OCTOBER 26, 2023
Architectural Project #2214
REA PARK CLUBHOUSE
RENOVATION & ADDITIONS

ADDENDUM NO. 2

PROJECT: Rea Park Clubhouse Renovation and Additions
The City of Terre Haute – Board of Public Works

SHEET
SP-2

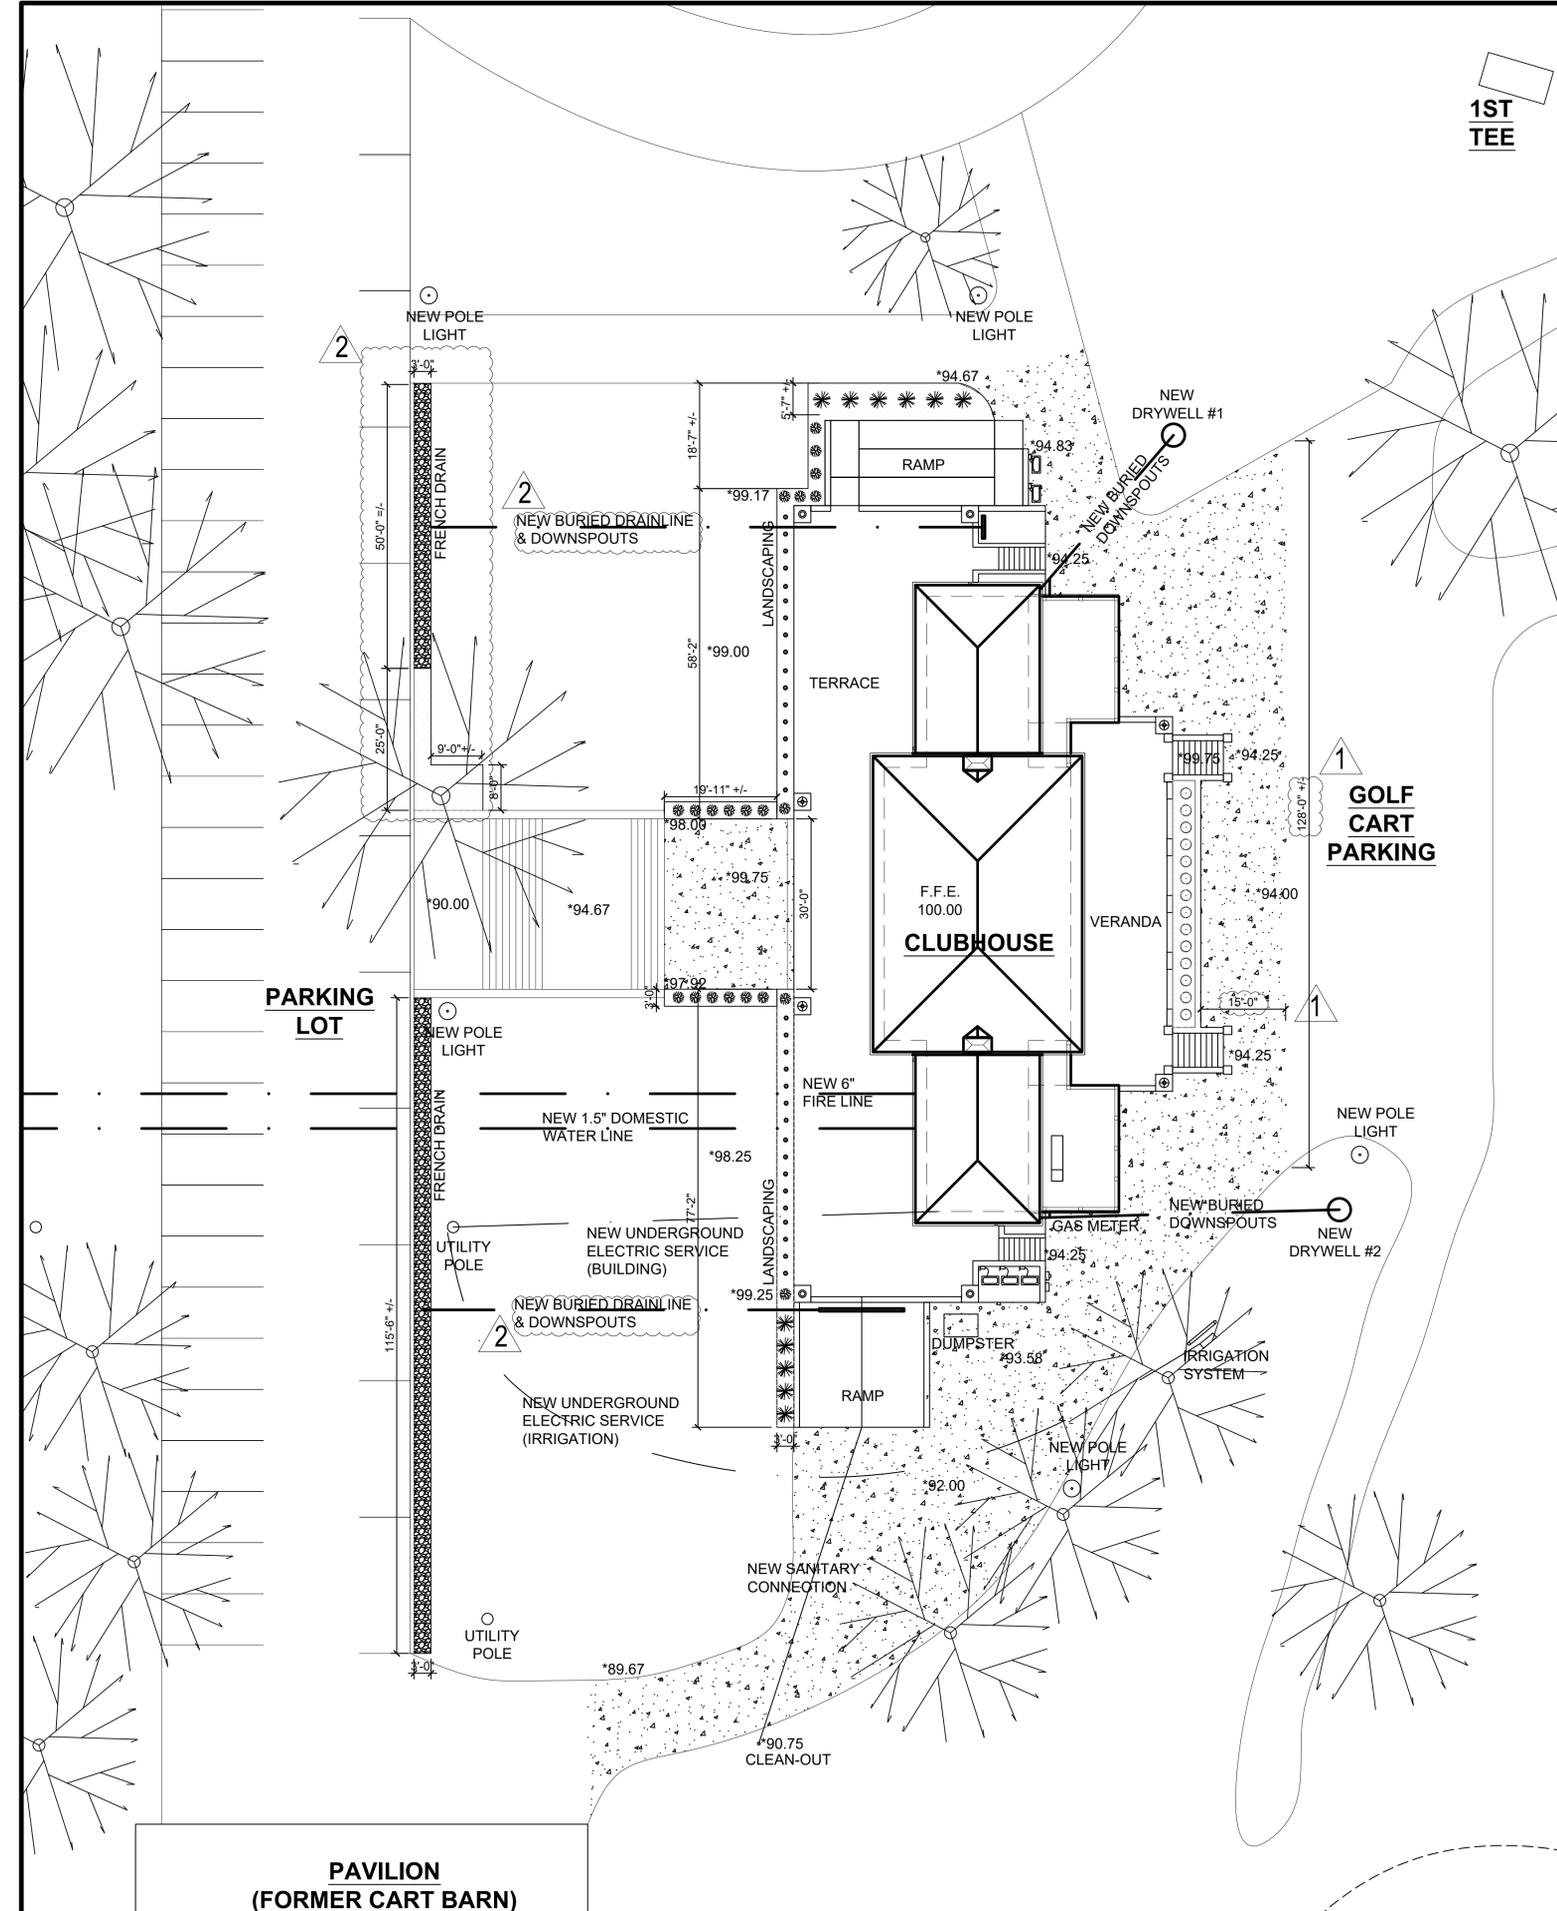
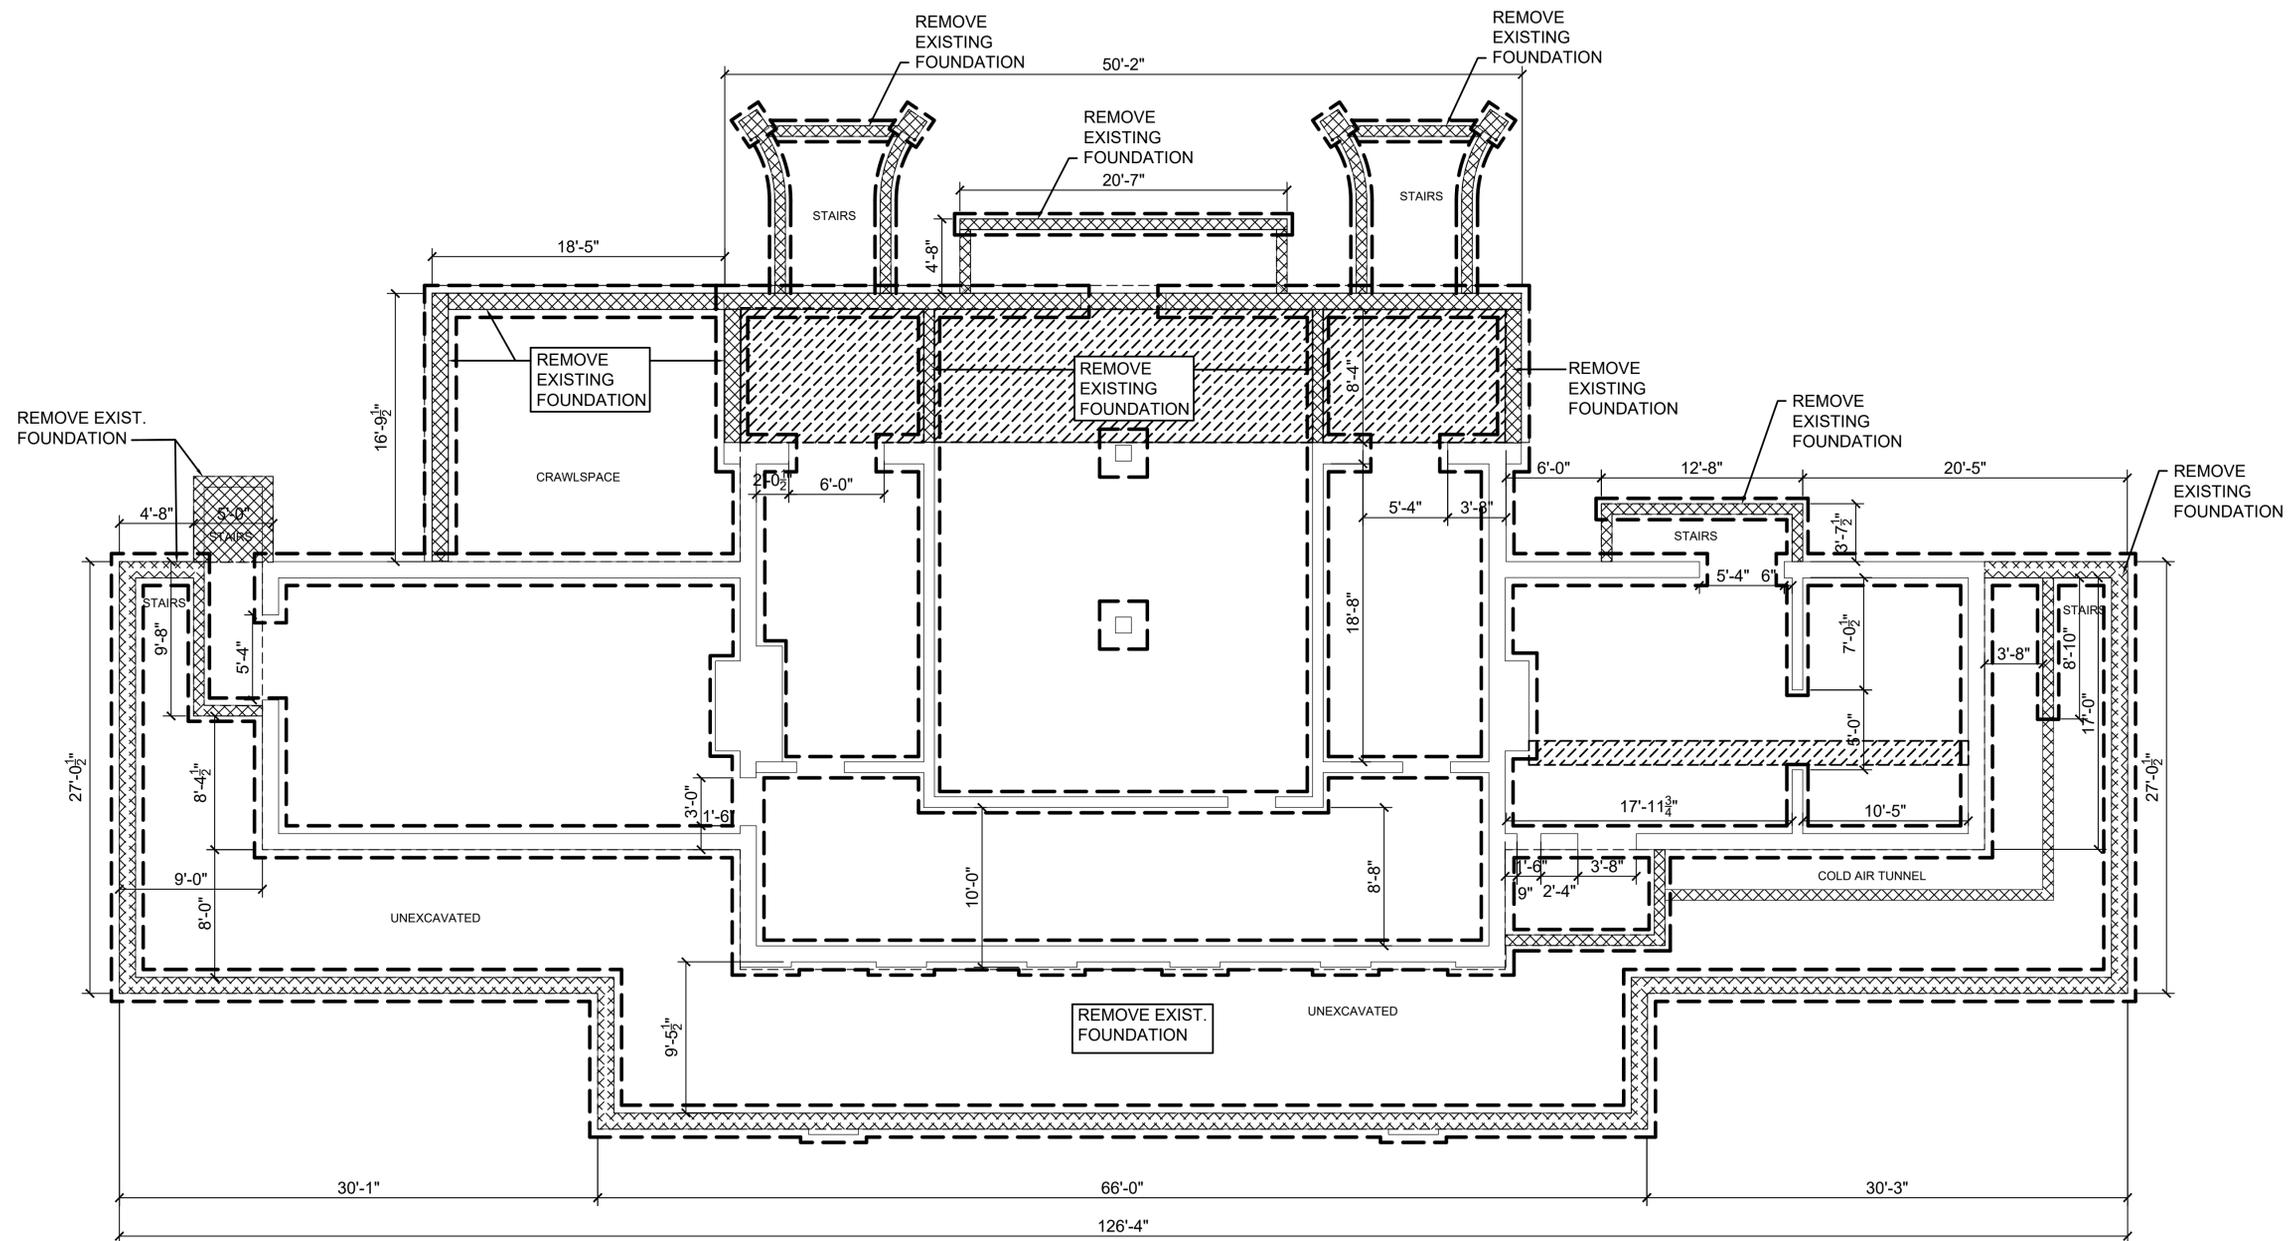
- Item #6 Asphalt pavement detail on Sheet SP-2 has been revised. (See revised Sheet **SP-2**)
- Item #7 New site plan has been revised on Sheet SP-2 to indicate stopping the french drain short of the existing tree. (See revised **Sheet SP-2**)

- Item #9 The French drain piping shall be 8" diameter HDPE, singlewall perforated pipe. The underground downspout drainage piping shall be 6" diameter solid PVC/SDR pipe. Connections shall be Schedule 40 PVC or Fernco adapters. (See detail on **Sheet SP-2**)

SHEET
D-0

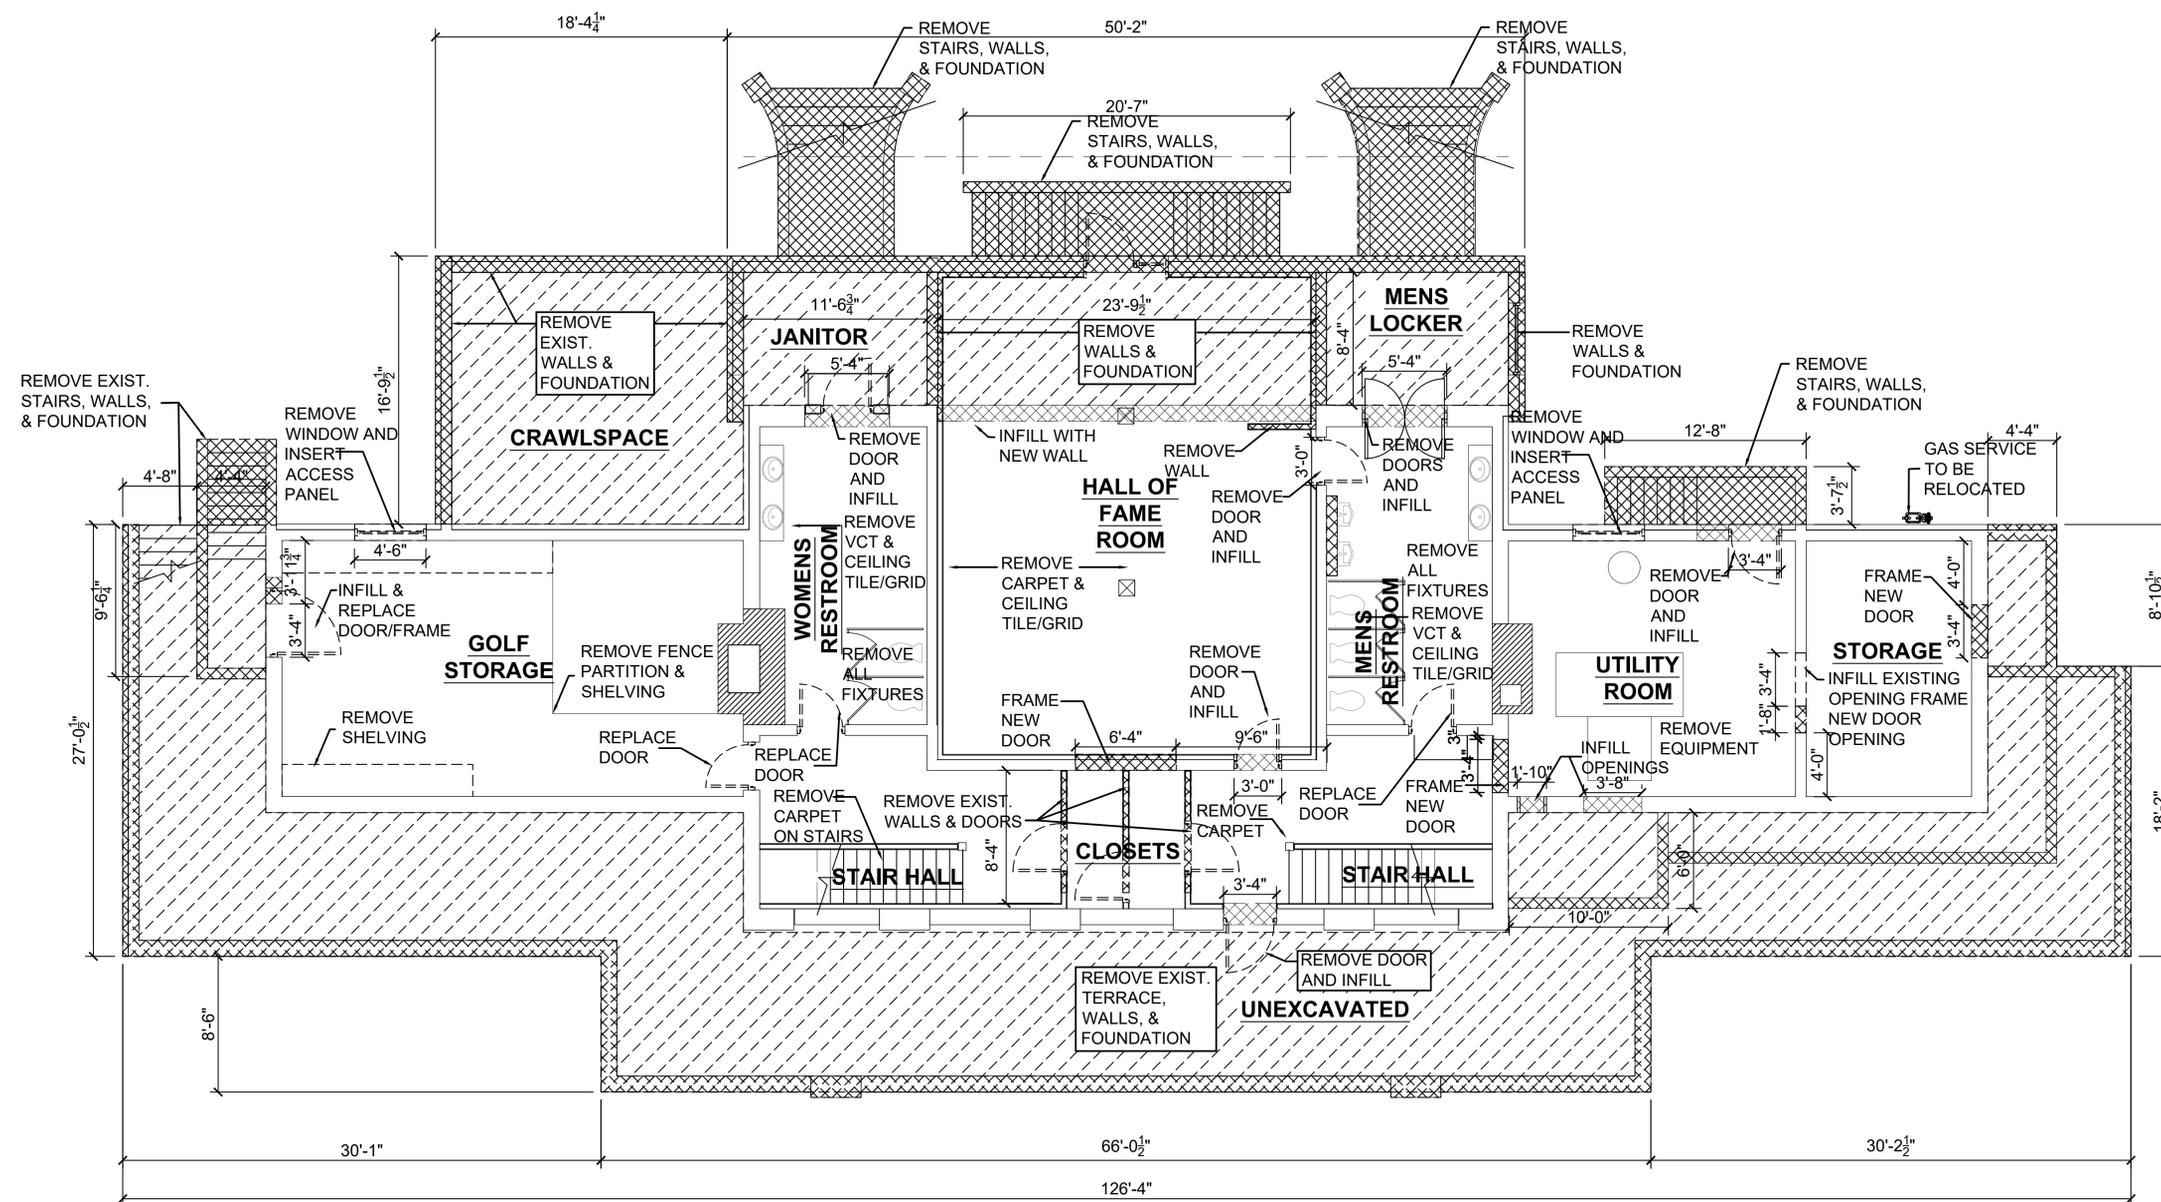
- Item #12 Downspout drainage has been added to the Basement Plumbing Plan. (See revised **Sheets P0.1 and P1.1**)
- Item #13 Contractor is responsible for all temporary shoring, bracing and other temporary construction necessary to ensure that the structural integrity of the existing structure is maintained during construction activities. Note has been added to Demolition Sheets. (See revised **Sheets D-0 thru D-4**)

DEMOLITION NOTE:
 CONTRACTOR IS RESPONSIBLE FOR ALL TEMPORARY SHORING, BRACING, AND OTHER TEMPORARY CONSTRUCTION NECESSARY TO ENSURE THAT THE STRUCTURAL INTEGRITY OF THE EXISTING STRUCTURE IS MAINTAINED DURING CONSTRUCTION ACTIVITIES.

A-5

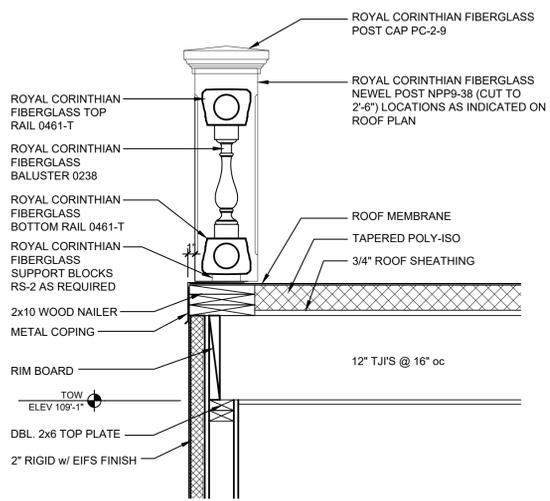
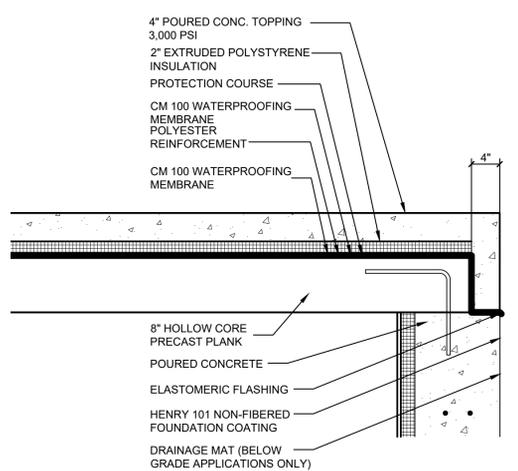
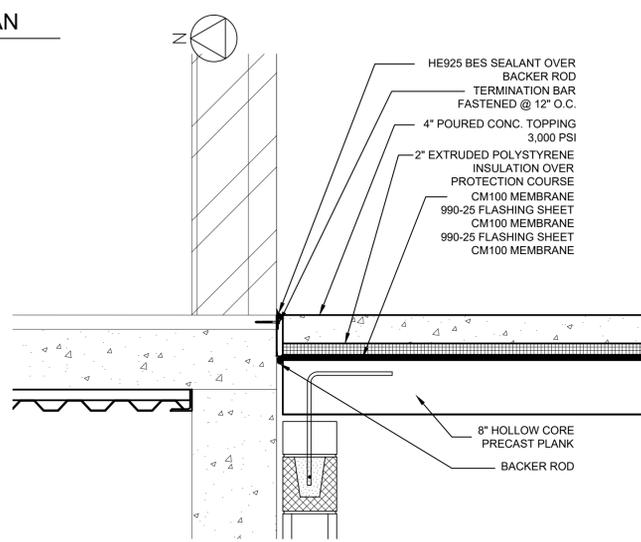
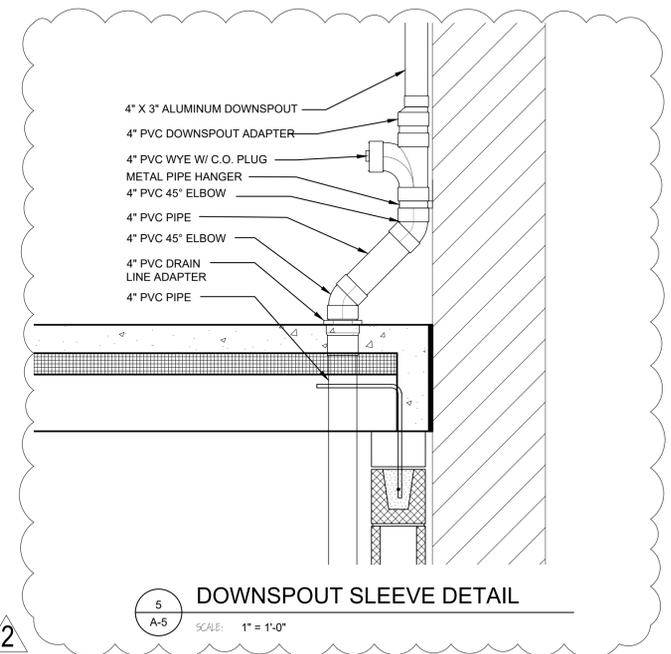
- Item #10 Contractor to provide 4X8 project job sign. (See detail on **Sheet SP-1**)
- Item #11 2 downspouts have been relocated to the north and south sides of the building. A detail regarding the downspout boot/sleeve through the Terrace structure has been added to Sheet A-5 (See revised **Sheet A-5**)
